BUTTERFIELD SUMMARY OF CHANGES FROM ORIGINAL EAF B4-A APPROVED ZONING

SITE PLAN

CONCEPT SITE PLAN
PREPARED FOR
BUTTERFIELD SITE
1756 NEW YORK 9D
TOWN OF COLD SPRINGS
PUTNAM COUNTY

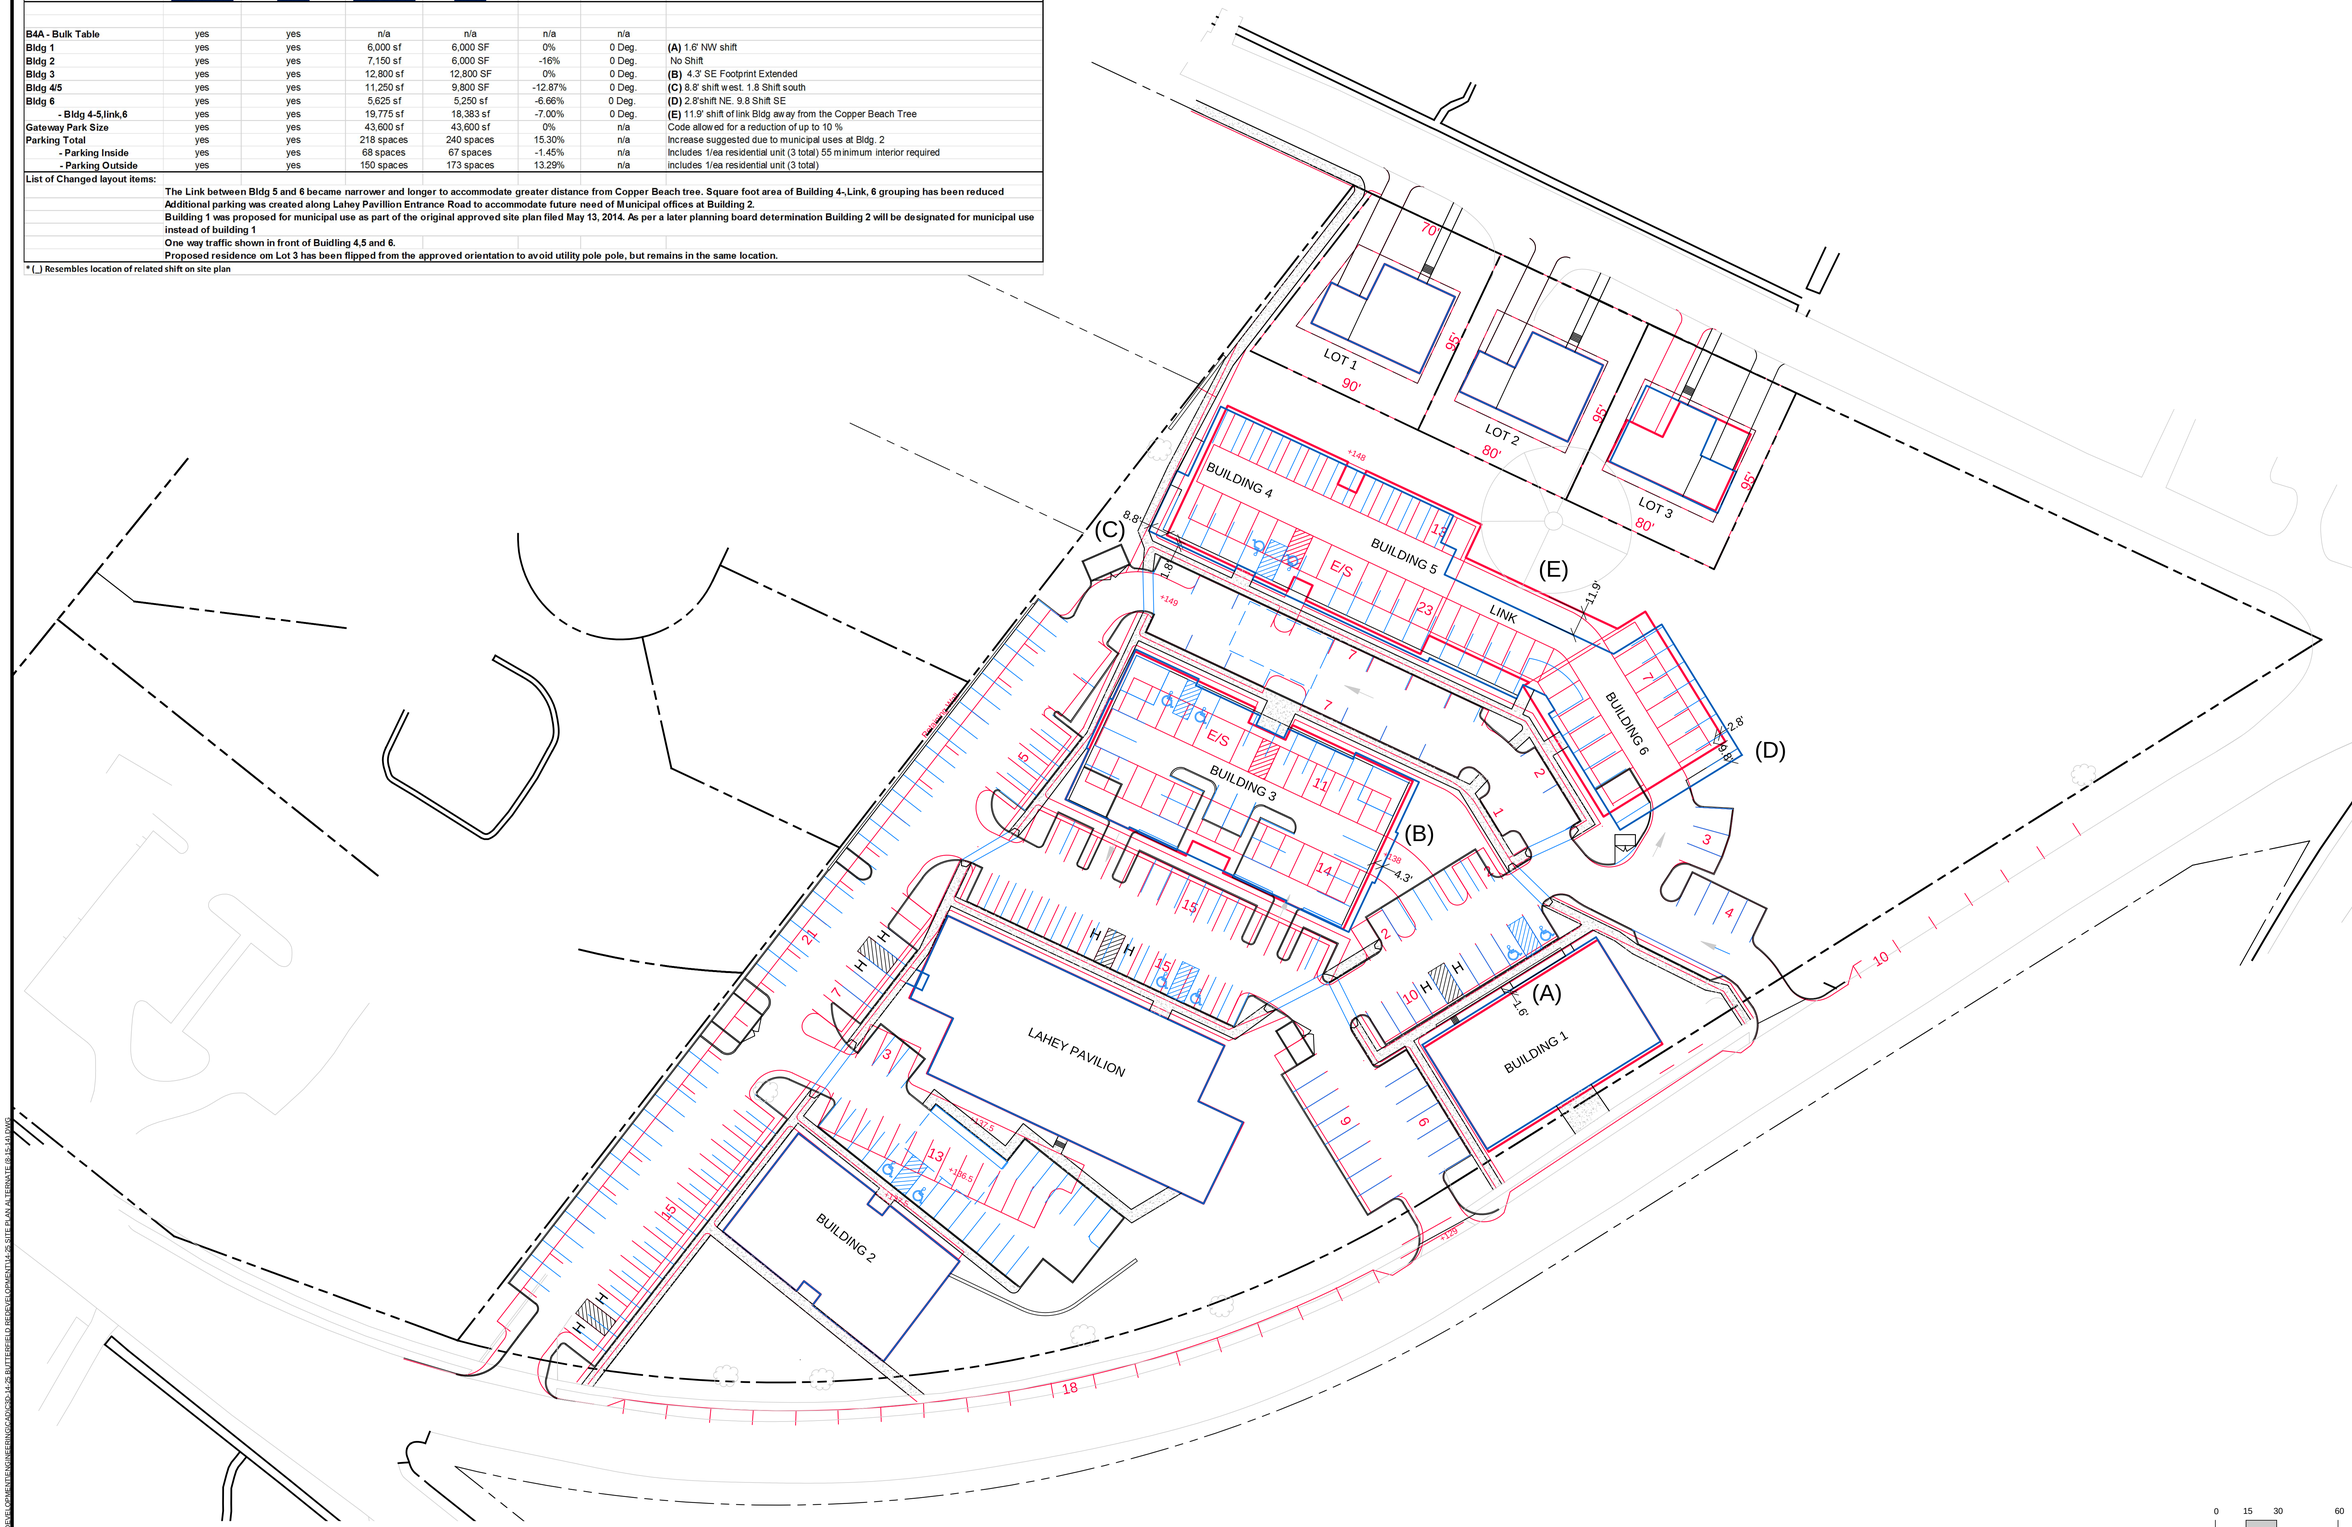
Information	EAF zoning conformance	Proposed Plan Zoning Conformance	Original Approved EAF Plan Footprint (SF)	Proposed Plan Footprint (SF)	Differential %	Change of Bldg. Rotational Location	Max Shift of Building in any Direction AND/OR Notes
						15 Degrees allowed	No more that 15' or up to 25' with PB permission No increase in Building size No change in rotational location by more that 15 degrees
	Filed (5/13/14)	(9/9/14)	Filed (5/13/14)	(9/9/14)			
B4A - Bulk Table	yes	yes	n/a	n/a	n/a	n/a	
Bldg 1	yes	yes	6,000 sf	6,000 SF	0%	0 Deg.	**(A)** 1.6' NW shift
Bldg 2	yes	yes	7,150 sf	6,000 SF	-16%	0 Deg.	No Shift
Bldg 3	yes	yes	12,800 sf	12,800 SF	0%	0 Deg.	**(B)** 4.3' SE Footprint Extended
Bldg 4/5	yes	yes	11,250 sf	9,800 SF	-12.87%	0 Deg.	**(C)** 8.8' shift west. 1.8 Shift south
Bldg 6	yes	yes	5,625 sf	5,250 sf	-6.66%	0 Deg.	**(D)** 2.8'shift NE. 9.8 Shift SE

- Bldg 4-5,link,6	yes	yes	19,775 sf	18,383 sf	-7.00%	0 Deg.	**(E)** 11.9' shift of link Bldg away from the Copper Beach Tree
Gateway Park Size	yes	yes	43,600 sf	43,600 sf	0%	n/a	Code allowed for a reduction of up to 10 %
Parking Total	yes	yes	218 spaces	240 spaces	15.30%	n/a	Increase suggested due to municipal uses at Bldg. 2

- Parking Inside	yes	yes	68 spaces	67 spaces	-1.45%	n/a	Includes 1/ea residential unit (3 total) 55 minimum interior required
- Parking Outside	yes	yes	150 spaces	173 spaces	13.29%	n/a	includes 1/ea residential unit (3 total)

The Link between Bldg 5 and 6 became narrower and longer to accommodate greater distance from Copper Beach tree. Square foot area of Building 4-,Link, 6 grouping has been reduced
Additional parking was created along Lahey Pavillion Entrance Road to accommodate future need of Municipal offices at Building 2.
Building 1 was proposed for municipal use as part of the original approved site plan filed May 13, 2014. As per a later planning board determination Building 2 will be designated for municipal use instead of building 1
One way traffic shown in front of Buidling 4,5 and 6.
Proposed residence om Lot 3 has been flipped from the approved orientation to avoid utility pole pole, but remains in the same location.
